Proposal for amendment to Regulation No. 46 (Devices for indirect vision)

The modifications to the current text of UN Regulation No. 46 are marked in bold for new characters and strikethrough for deleted characters.

Figure 11a

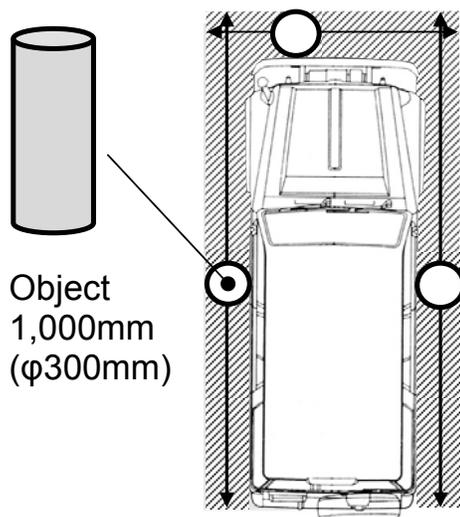
"**15.2.4.8. Class VIII close-proximity and rear-view device**
15.2.4.8.1. Close-proximity and rear-view device for the vehicle's close-proximity (see Figure 11a)

The field of vision shall be bounded by:

- (a) A transverse vertical plane through the outermost point of the front of the vehicle;**
- (b) A transverse vertical plane in front of the plane defined in (a);**
- (c) Two longitudinal vertical planes parallel to the longitudinal vertical median plane of the vehicle, each of which is situated 300 mm outside the outermost side of the vehicle on the driver's side and opposite to the driver's side, respectively; and**
- (d) A plane passing through the rearmost point of the vehicle and parallel to the transverse vertical plane of the vehicle.**

Figure 11b

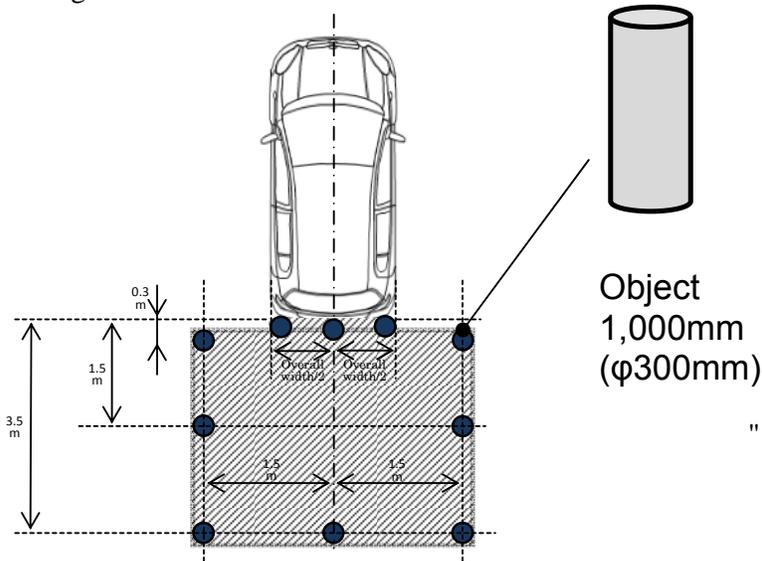
15.2.4.8.2. Close-proximity and rear-view device for the rear of the vehicle (see Figure 11b)

The field of vision shall be bounded by:

- (a) A transverse vertical plane through the outermost point of the rear of the vehicle;**
- (b) A transverse vertical plane 3,500 mm behind the plane defined in subparagraph (a) above;**
- (c) Two longitudinal vertical planes parallel to the longitudinal vertical median plane of the vehicle, each of which is situated at a distance of 1,500 mm from that plane on either side, respectively; and**
- (d) For the area between the two longitudinal vertical planes defined in subparagraph (c) above and within the width of the vehicle, a transverse vertical plane 300 mm behind the plane defined in (a).**
